4.3 Building B elevations

Building B north-east elevation current proposed changes

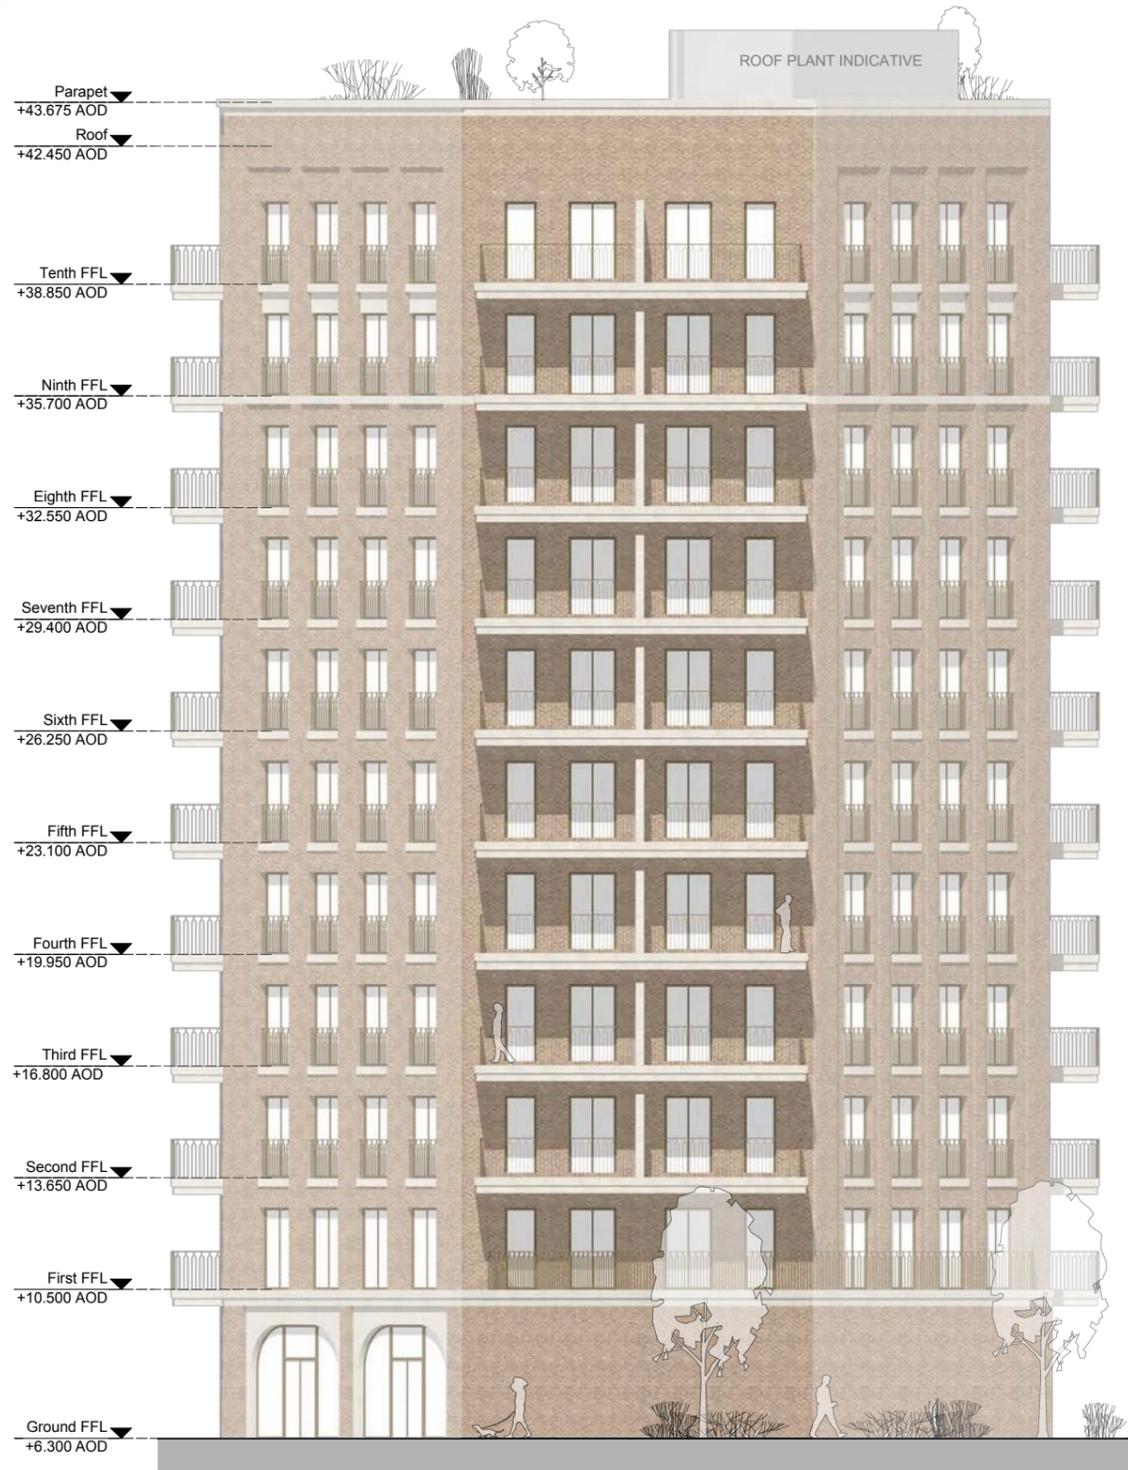
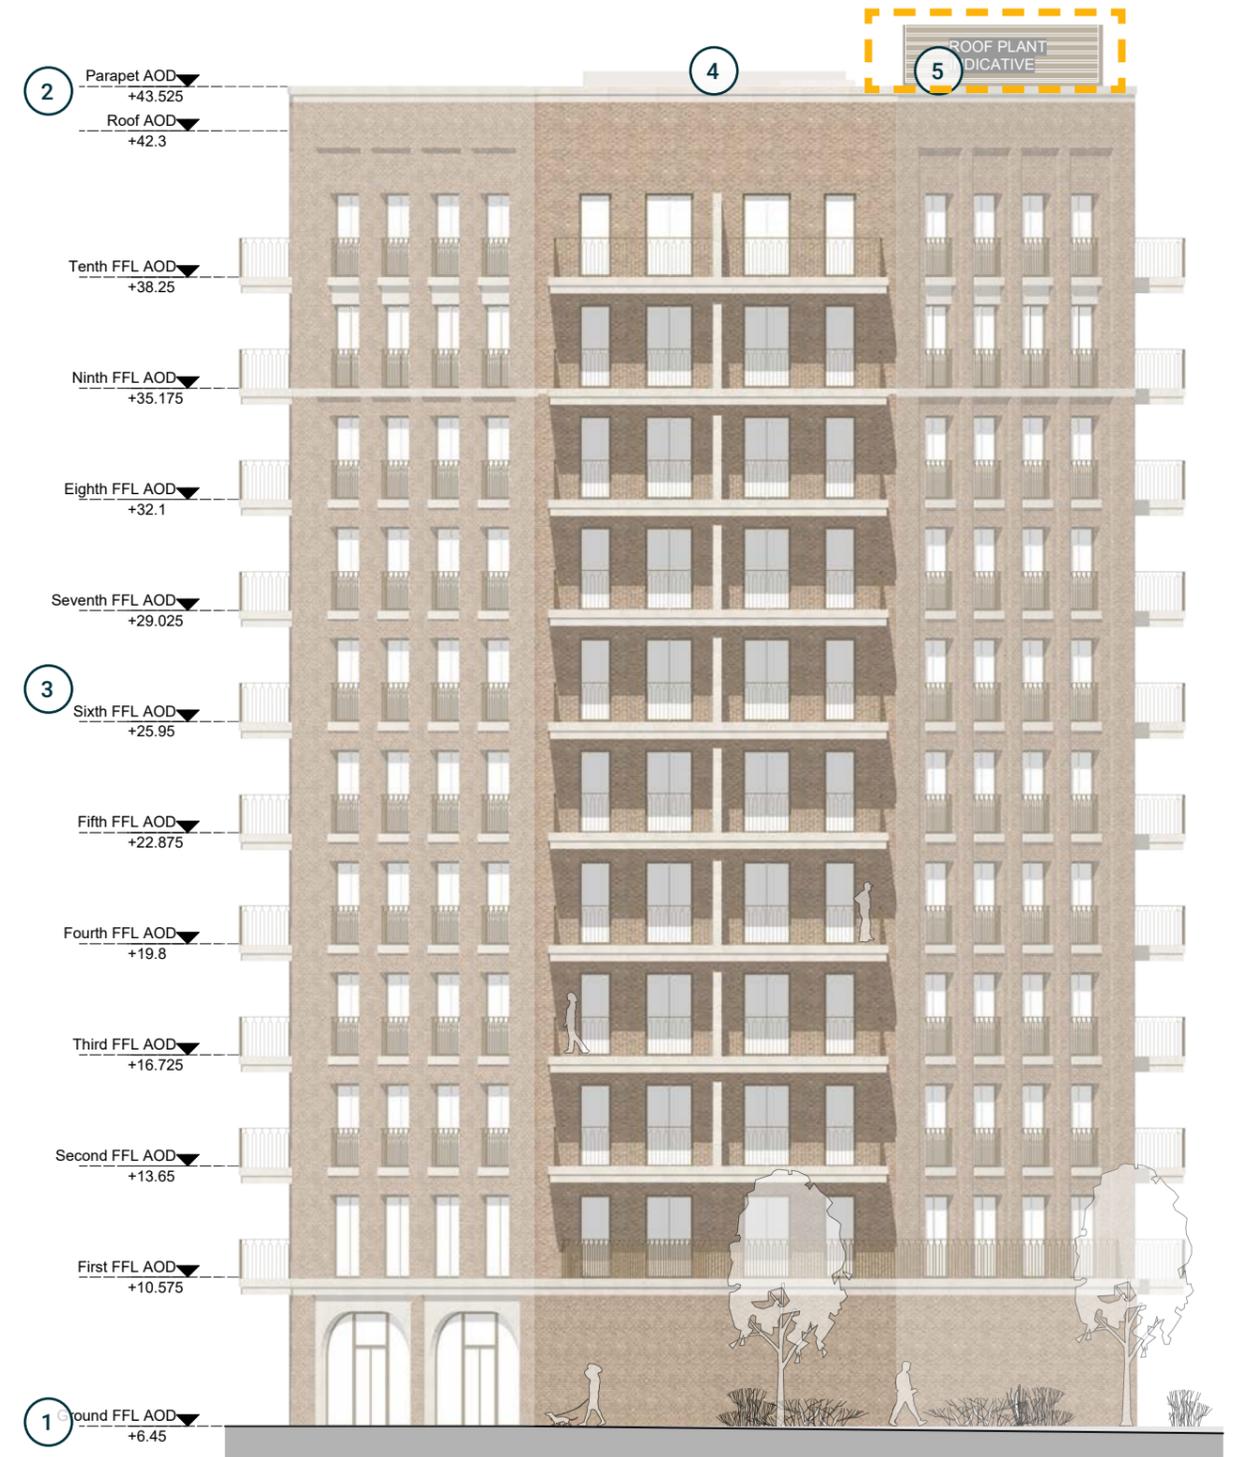
- ① Ground floor FFL increased by 15cm from +6.3 to +6.45
- ② Parapet height reduced by 15cm (from +43.675 to +43.525)
- ③ Floor to floor heights (1st to 10th floors) each reduced by 7.5cm
- ④ Residential terrace removed
- ⑤ Roof plant enclosure consolidated

Building B east elevation current proposed changes

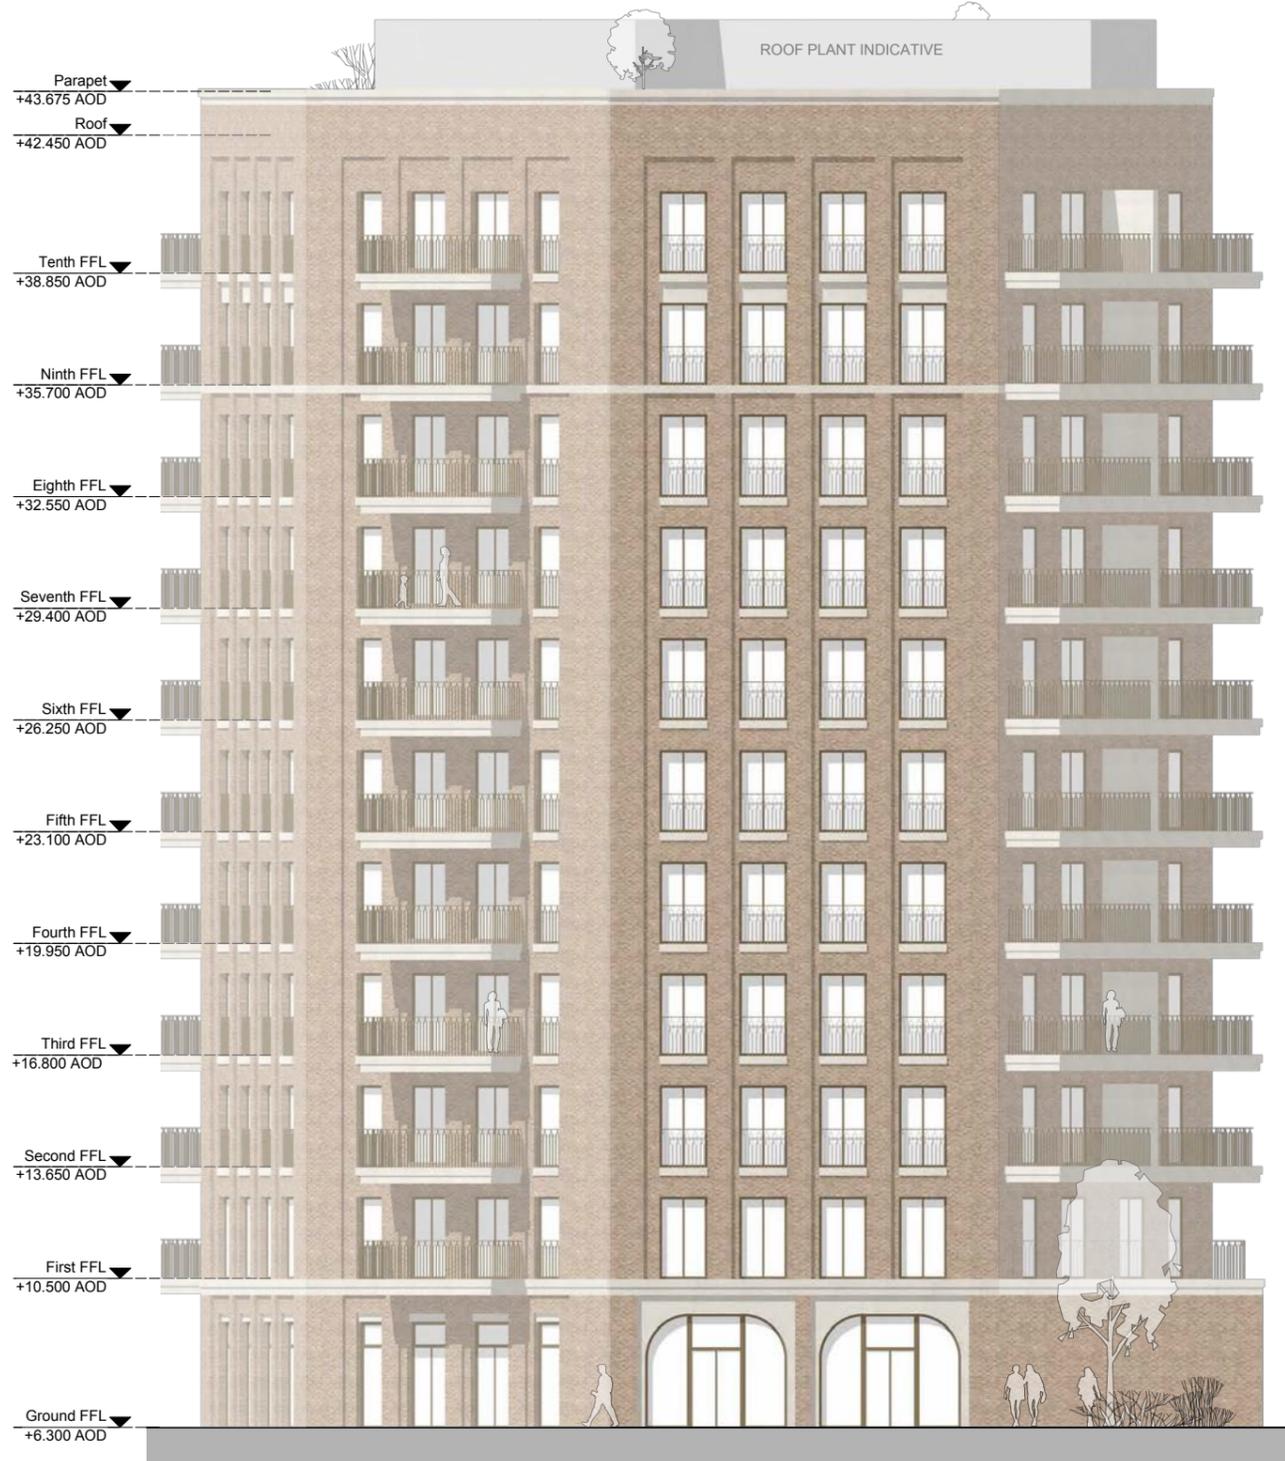
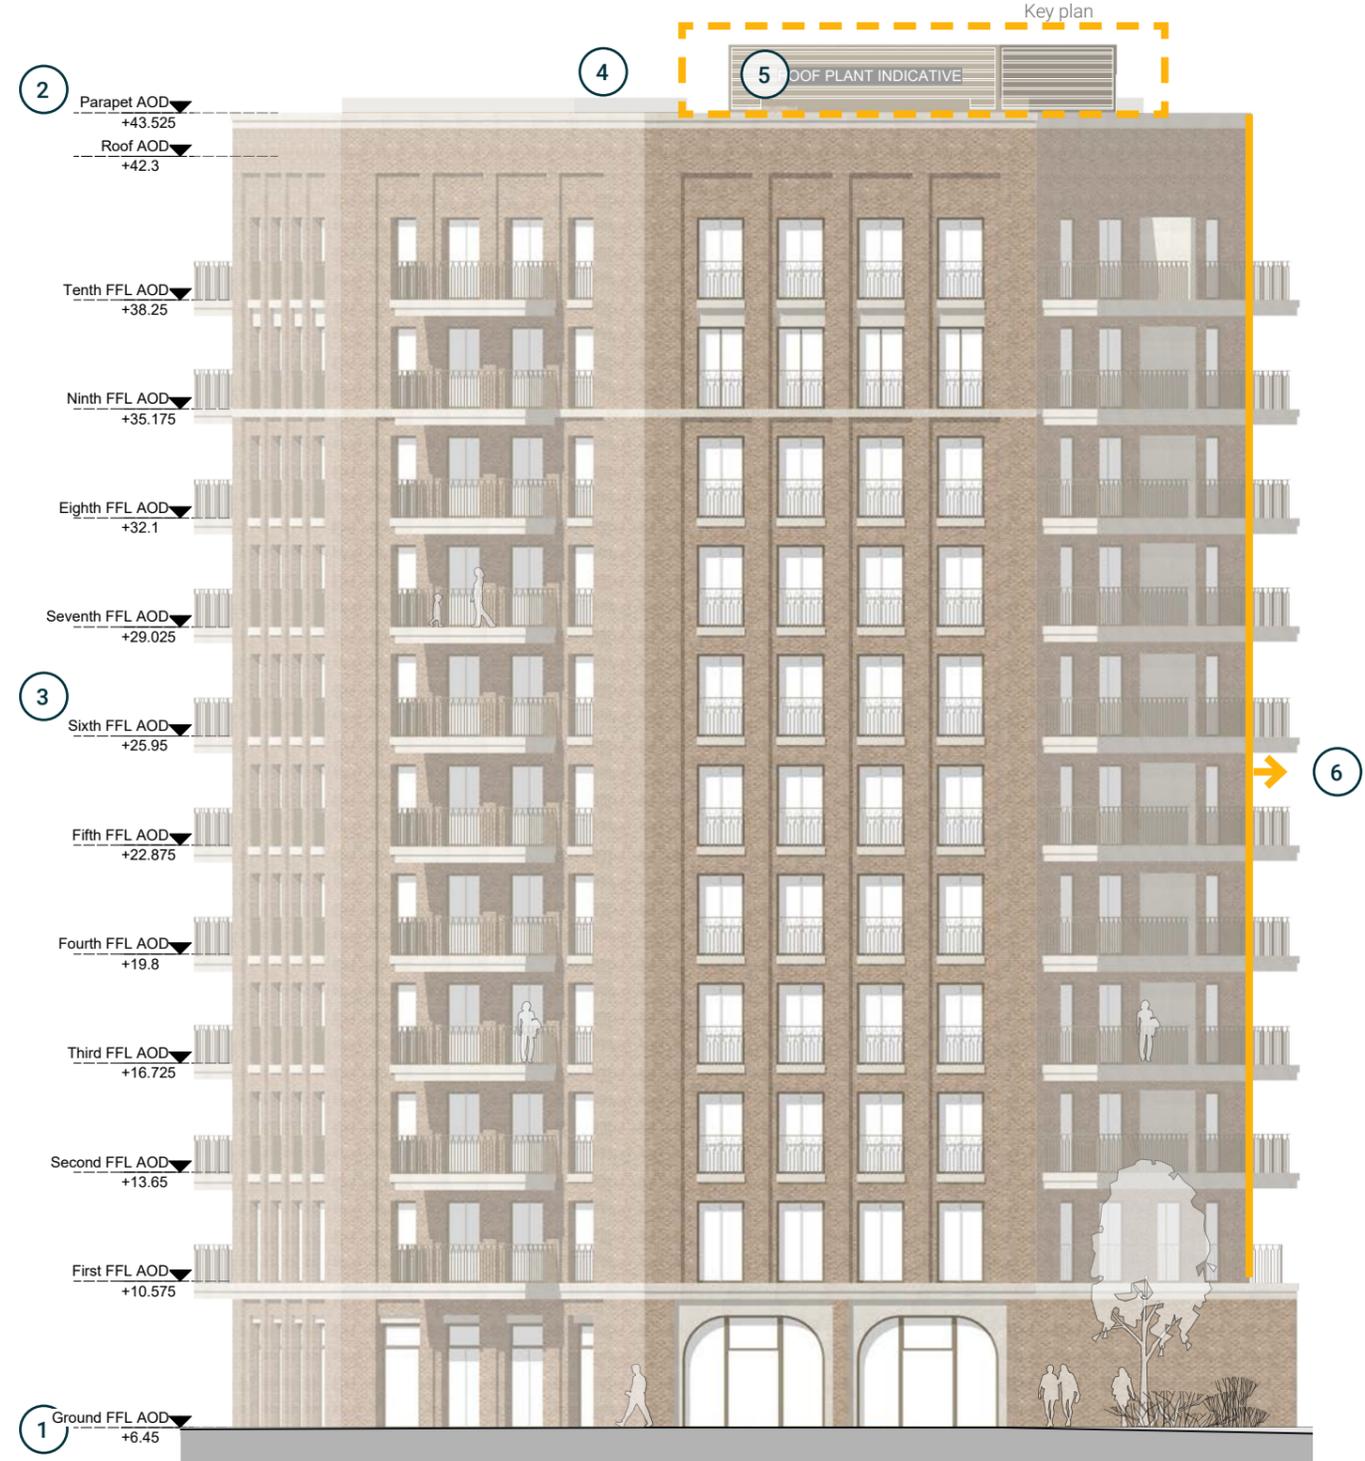
- ① Ground floor FFL increased by 15cm from +6.3 to +6.45
- ② Parapet height reduced by 15cm (from +43.675 to +43.525)
- ③ Floor to floor heights (1st to 10th floors) each reduced by 7.5cm
- ④ Residential terrace removed
- ⑤ Roof plant enclosure consolidated
- ⑥ a 112.5mm (or 11.25cm) extension in building footprint to the north

Building B south-east elevation current proposed changes

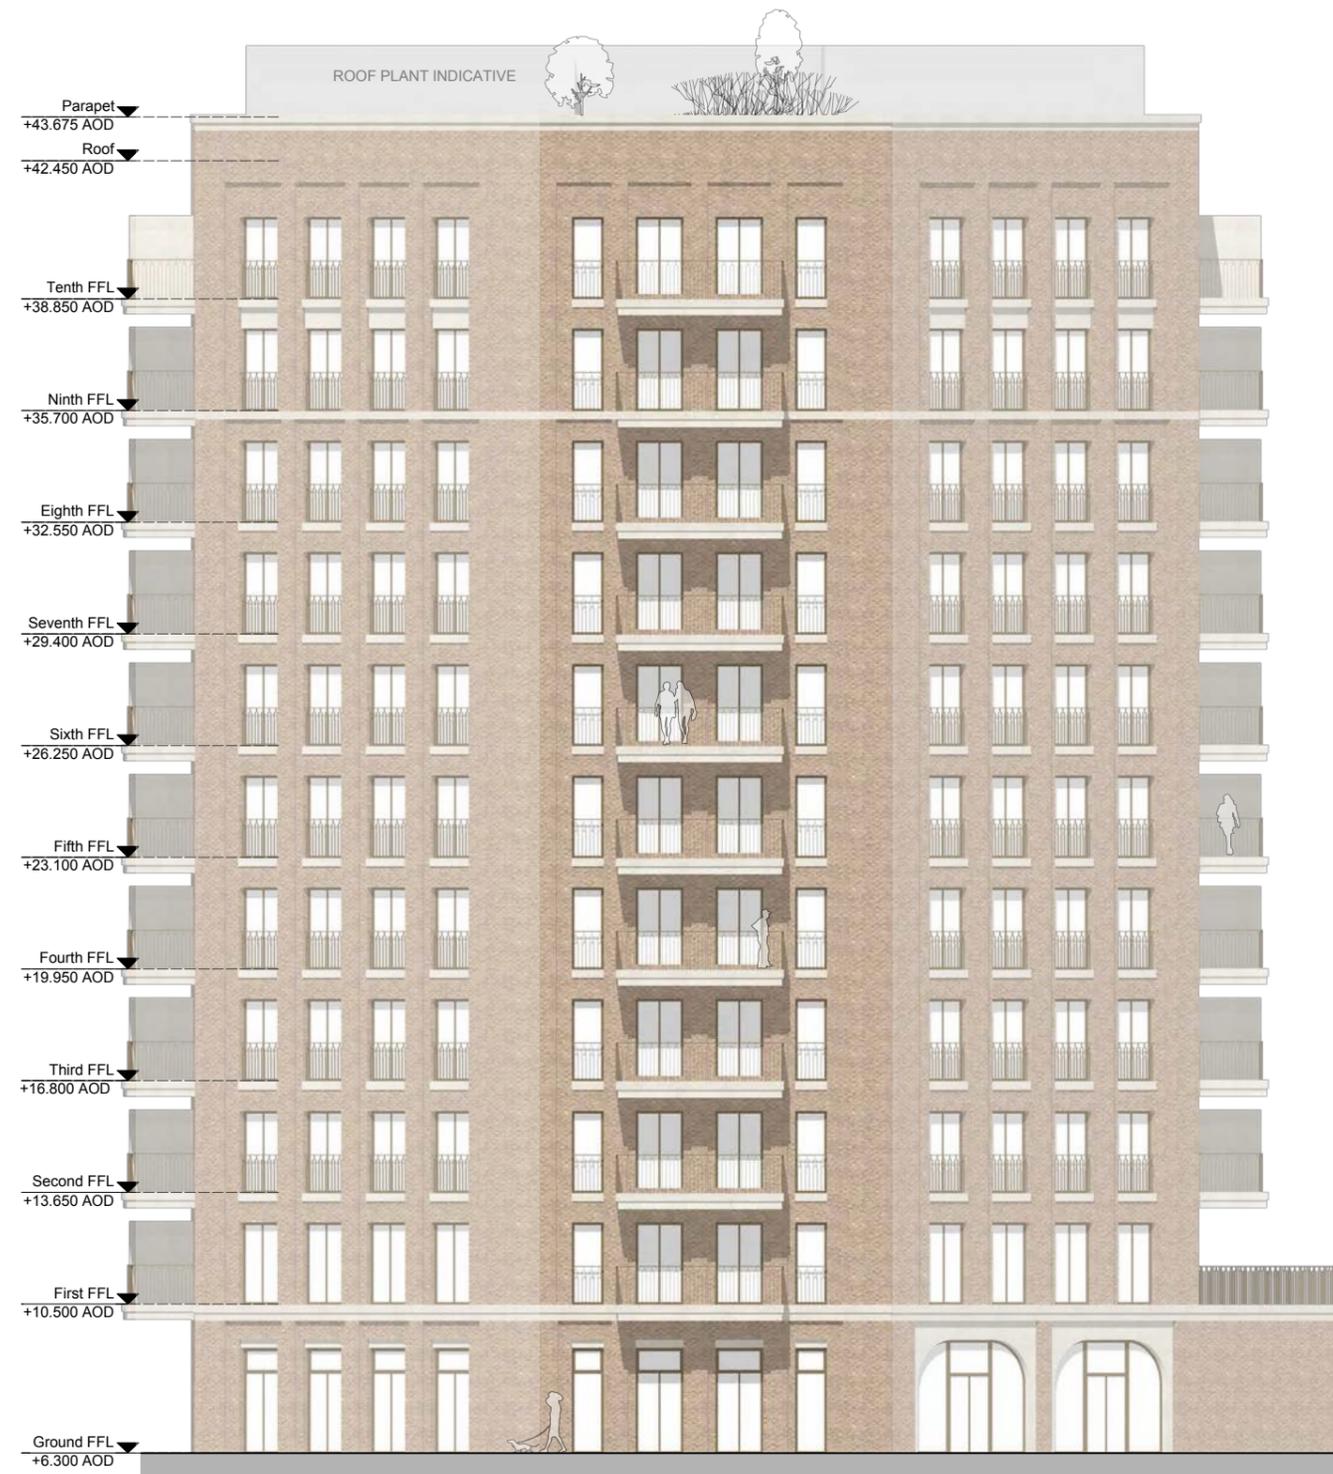
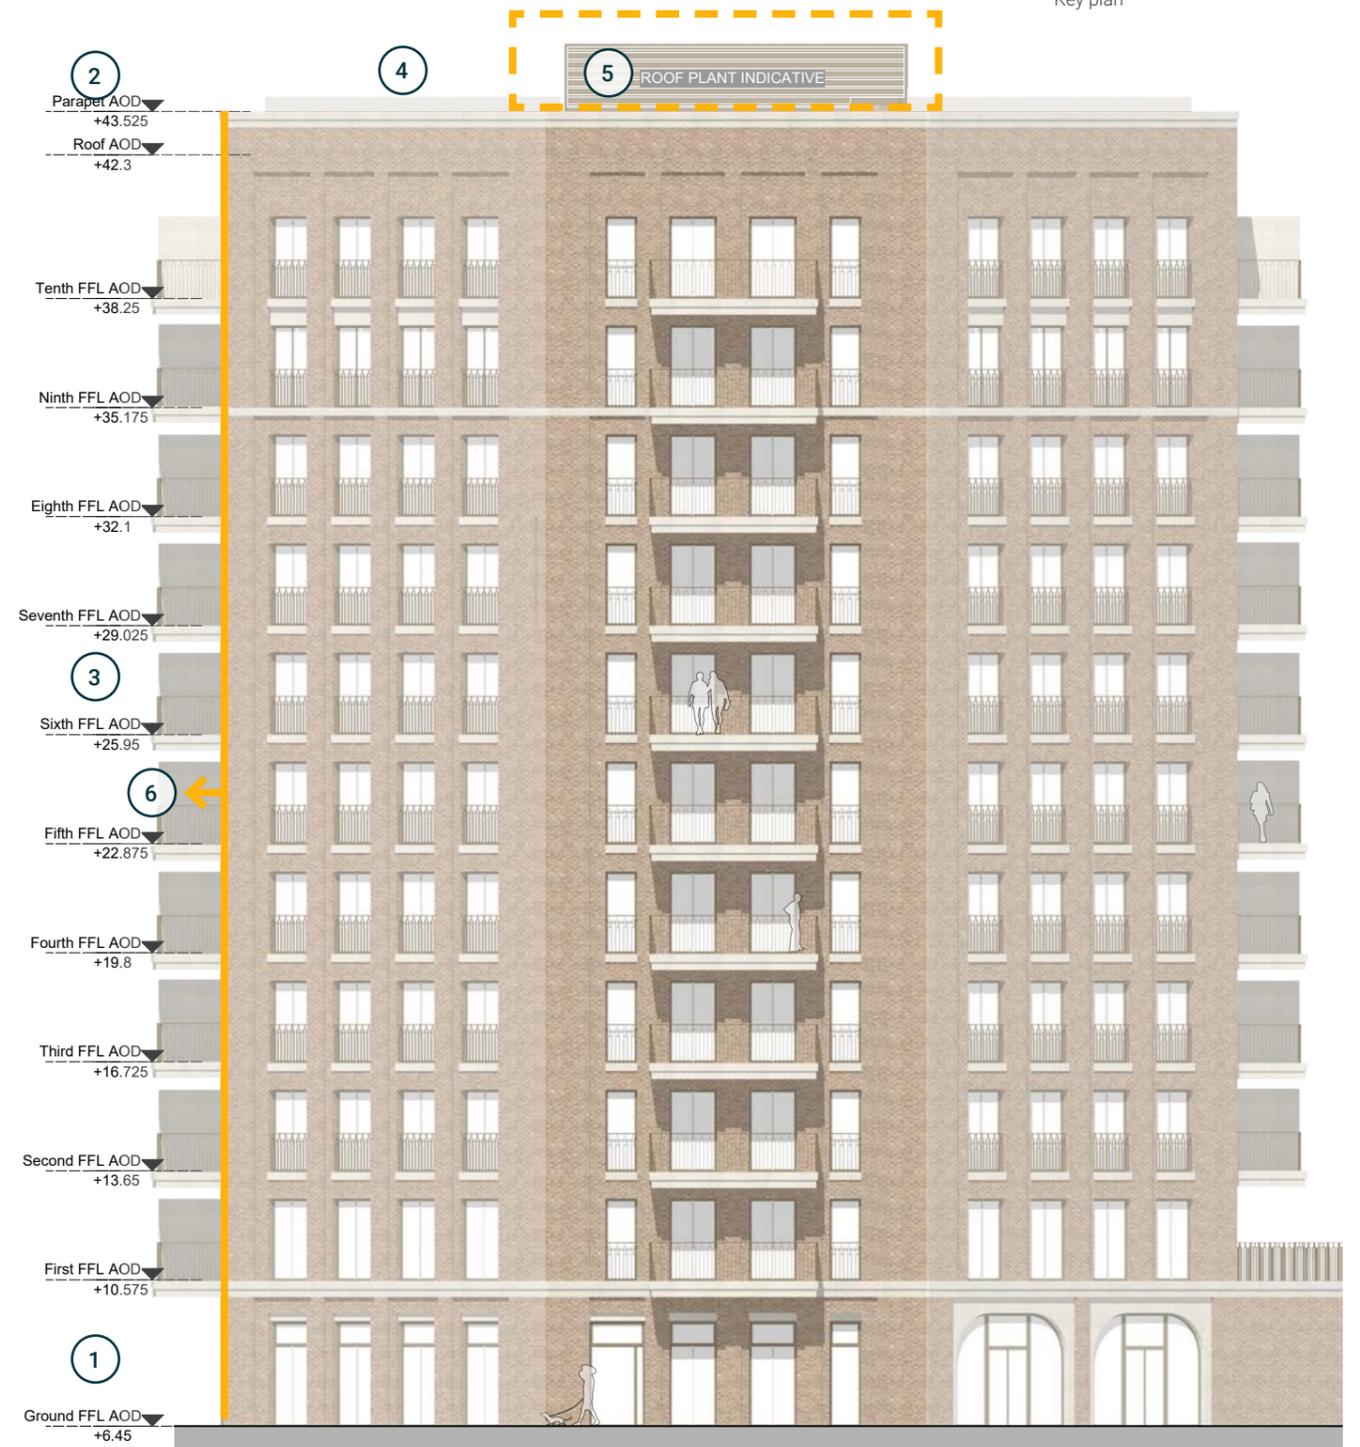
- 1 Ground floor FFL increased by 15cm from +6.3 to +6.45
- 2 Parapet height reduced by 15cm (from +43.675 to +43.525)
- 3 Floor to floor heights (1st to 10th floors) each reduced by 7.5cm
- 4 Residential terrace removed
- 5 Roof plant enclosure consolidated
- 6 a 112.5mm (or 11.25cm) extension in building footprint to the south
